3.4 Instrumentation and Control

The information in this section of the reference ABWR DCD, including all subsections, tables, and figures, is incorporated by reference with the following departure.

STD DEP T1 3.4-1 [\(Figure 3.4b\)](#)

Figure 3.4b Safety System Logic & Control Block Diagram

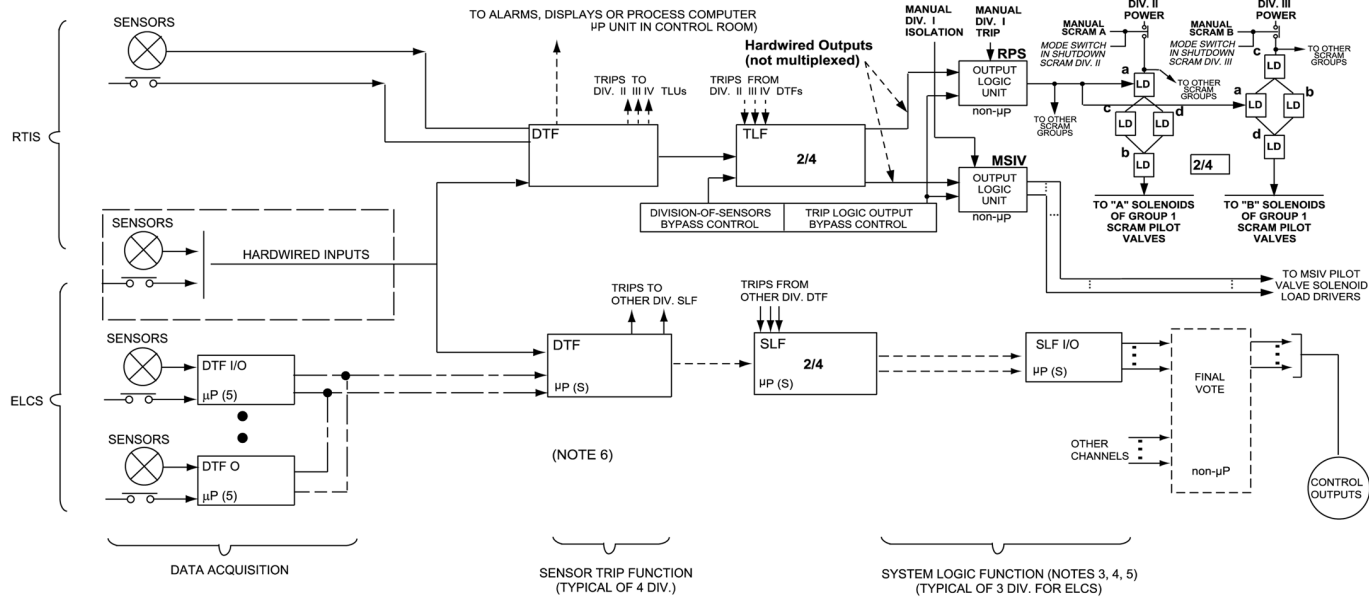
The basic ~~hardware~~ functional configuration for one division of SSLC is shown in Figure 3.4b. Each division runs independently (i.e., asynchronously) with respect to the other divisions. The following steps describe the processing sequence and associated function descriptions for incoming sensor signals and outgoing control signals. These steps are performed simultaneously and independently in each of the four divisions:
